ADDENDUM NO. 1

**ELEVATOR ADDITION FOR CAMPBELL COURT ES, HENRY COUNTY PUBLIC SCHOOLS
RRMM ARCHITECTS
ROANOKE, VIRGINIA
COMM. NO. 21195-18**

8-11-25

4160 BOND-N-FLASH

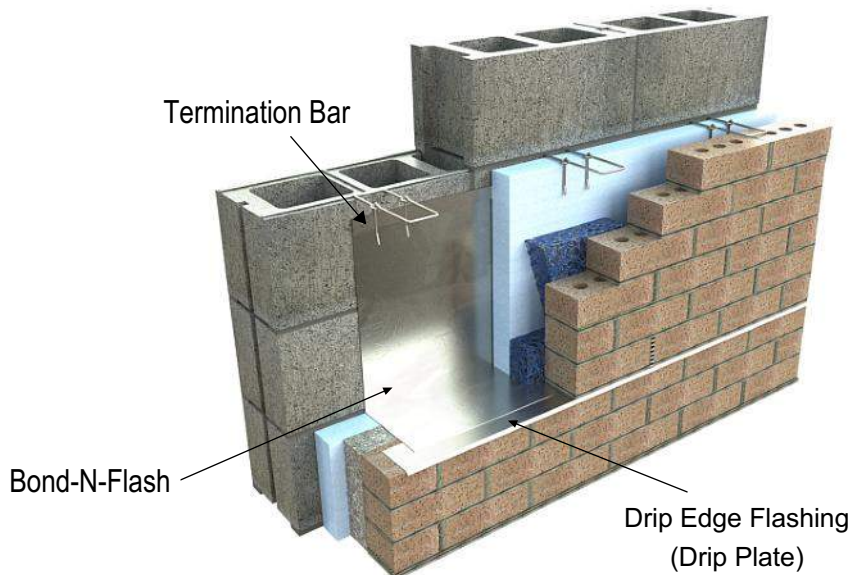
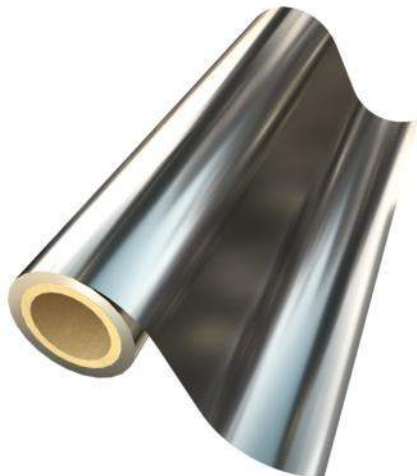
Can the York branded steel flashing (called out in 2.9 Embedded Flashing Materials in the Div 4 unit masonry specs) be substituted with the attached Wirebond product?

YES AS LONG AT IT MEETS THE SPECIFICATIONS
